PREFERRED PROJECT REPORT

**LOT 104, 42 WALKER STREET, RHODES
(PRECINCT C)**

SEPTEMBER 2007

Figure 2: Amended Level 1 of the development showing (circled) apartment access to Shoreline Avenue

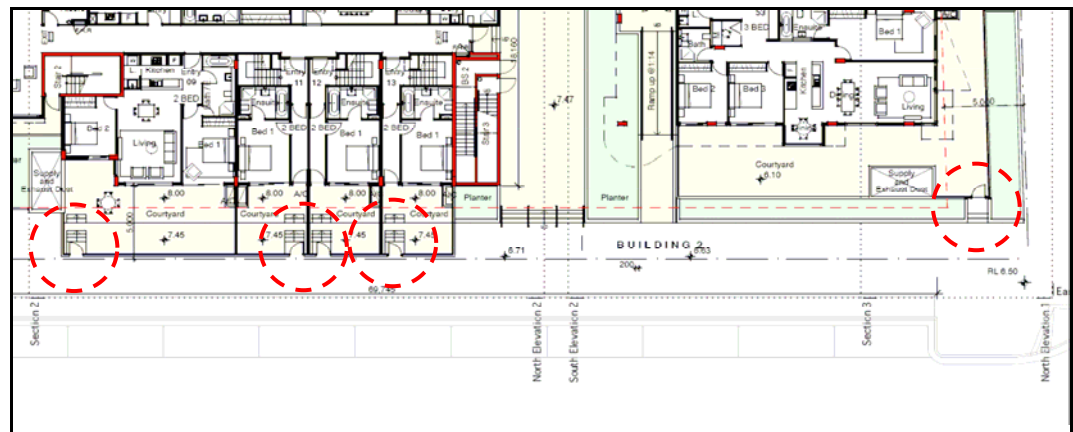
Ground Floor Units – There are no ground floor units with direct access to the street. The Renewing Rhodes DCP requires 50% of units to have direct access to the street.

All apartments on the lower ground level (drawing 06 DA) have individual access from the street. The proposal has been amended so that all units facing Shoreline Drive are directly accessible from the street. **Figure 2** below shows the access to Shoreline Avenue from street level apartments.
